Model: Kir-C	Date: 30-May-01	No.: MB040001b
--------------	-----------------	----------------

MB Correction

Modified Article: Parts Catalog Correction		Prepared by: K. Miura	
From: Technical Services Dept., GTS Division			
Reason for Modification:	☒ Parts catalog correction	☐ Vendor change	☐ To meet standards ()
	☐ To facilitate assembly	☐ To improve reliability	
	☐ Part standardization	☐ Other

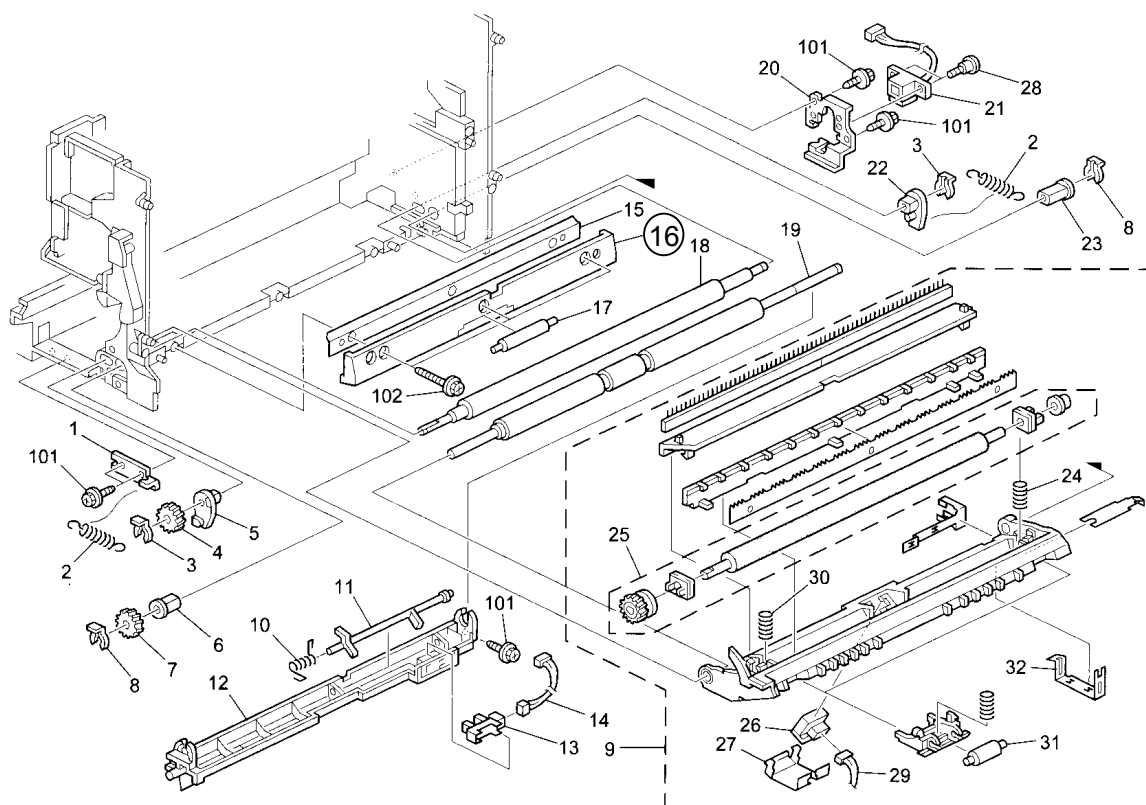
The following part has been modified to improve envelope feeding performance.

Old part number	New part number	Description	Q'ty	Int	Page	Index	Note
B0392557	B0392572	Guide - Left Registration Roller	1	O/O	27	16

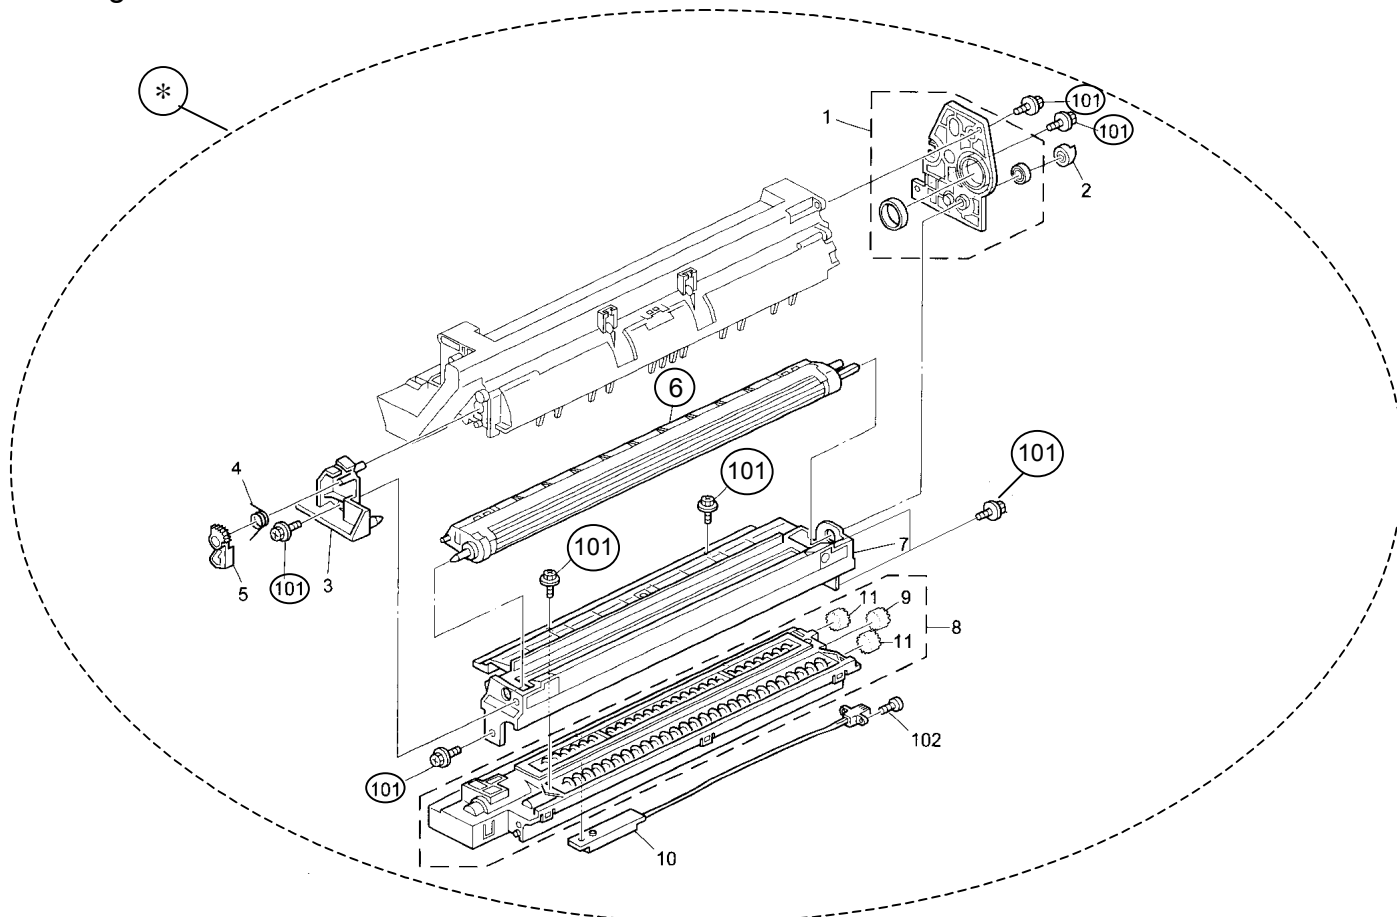
The material of the doctor blade has been changed to ensure that no developer carrier is attracted to the doctor blade itself. In accordance with this change, the Development Roller Assembly and PCU Assembly have been changed as shown below.

Also, the M3x6 Tapping Screw for the PCU has been modified to ensure that the screw hole is not stripped when the screw is inserted or removed.

Old part number	New part number	Description	Q'ty	Int	Page	Index	Note
B0392202	B0392203	PCU - Assembly	1	X/O	35	*	
B0393050	B0393051	Development Roller Assembly	1	X/O	35	6	
04513006B	03603006B	Screw - M3x6	-	X/O	35,36	101

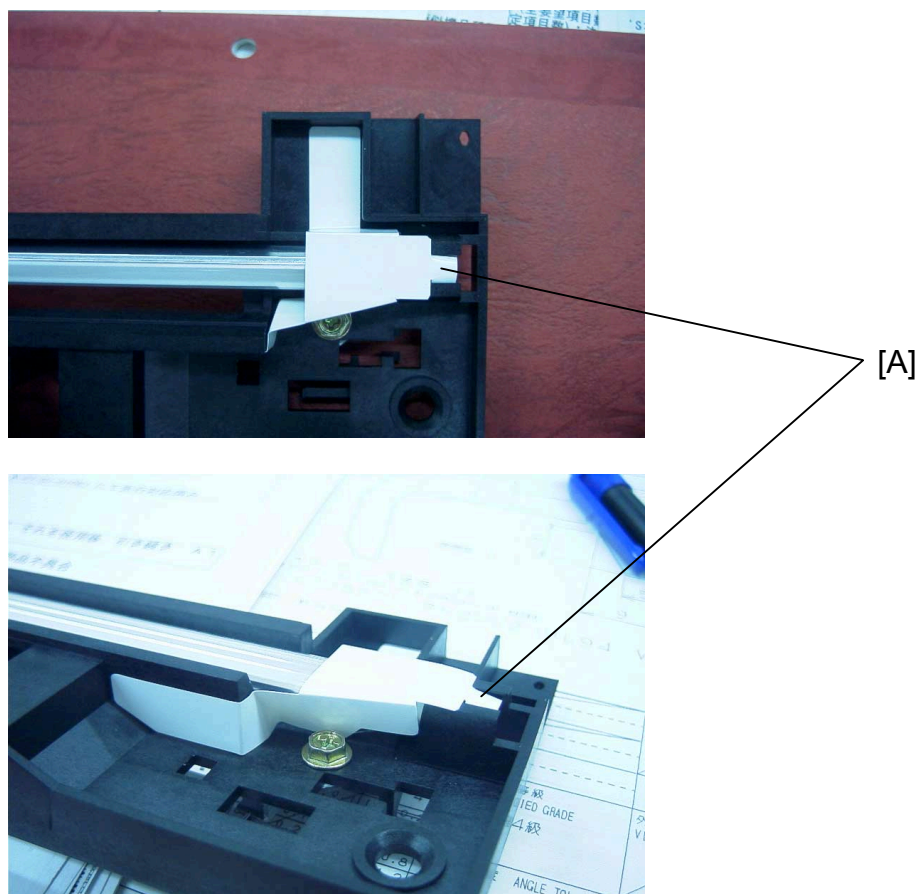
If the Rear Reflector of the 1st scanner is not properly secured, it can impact with the scanner inner frame when the scanner moves. The following parts have been changed to ensure that the Rear Reflector stays firmly attached and properly.
(See RTB RB040012 for details).

Old part number	New part number	Description	Q'ty	Int	Page	Index	Note
B0391740	B0391791	Xenon Lamp	1	X/O	17	10	
B0391741	B0391793	Rear Reflector	1	X/O	17	19

Note: The position [A] should be lower as follows:

Page 35

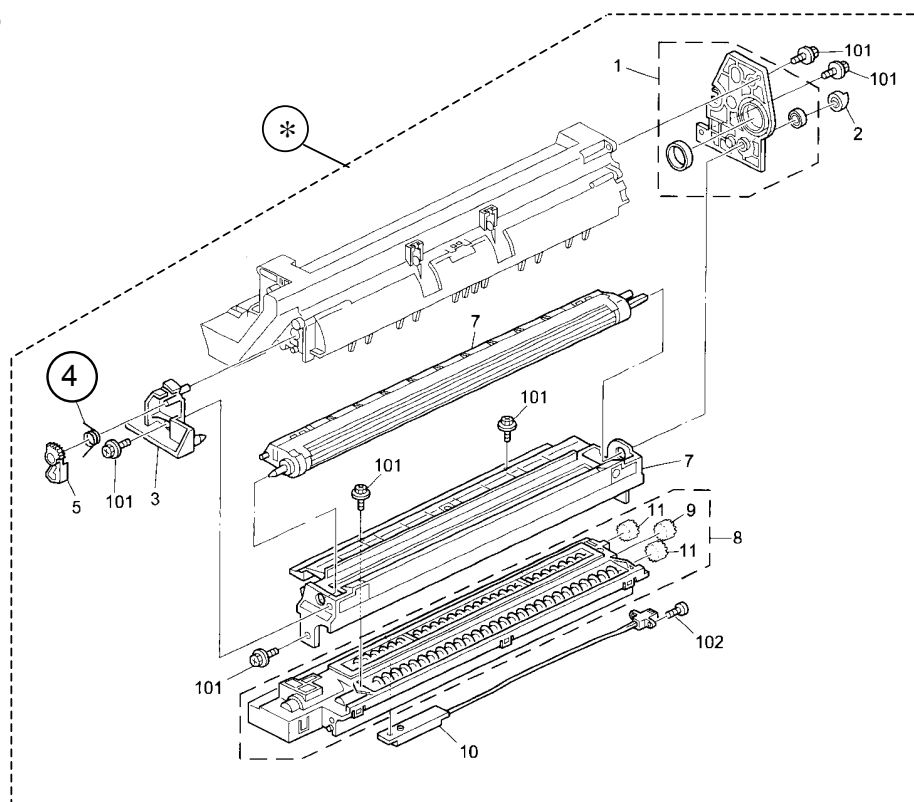
As announced in MB0400014, a Drum Shutter Stopper (B0392325) was added to ensure that the gear stays properly engaged. However, when the Stopper is set to the lowest position, the Shutter (B0392343) may not open due to friction that occurs when the Right Door is closed.

Old part number	New part number	Description	Q'ty	Int	Page	Index	Note
B0292203	B0392204	PCU - Assembly	1	O/O	35	*	
B0392366	B0392367	Shutter Spring	1	X/O	35	4	
	B0392329	Spacer - M3	2		37	24	
04523010B		Tapping Screw - M3x10			37	104	
	04523012B	Tapping Screw - M3x12		X/O	37	104

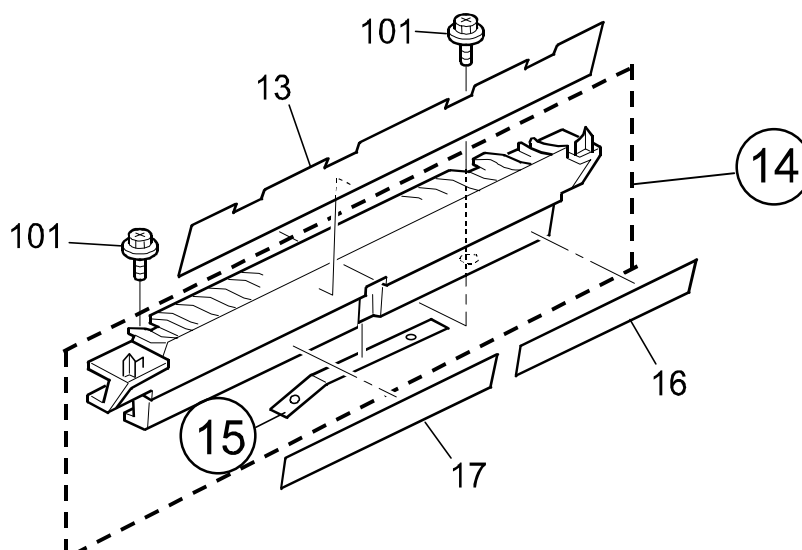
1. When opening the Duplex Paper Guide (B0434640), noise may occur if the guide contacts the Duplex Entrance Sensor. To ensure that the noise is not generated, a Mylar has been added to the Exit Guide Plate.
2. In addition, as it is difficult to attach the Exit Guide Grounding Plate (B0394485) to the Exit Guide Plate in the field, the guide plate now comes with the grounding plate attached.

Old part number	New part number	Description	Q'ty	Int	Page	Index	Note
B0434663	B0434670	Exit Guide Plate	1	X/O	45	14	
B0394485		Grounding Plate - Exit Guide	1		45	15
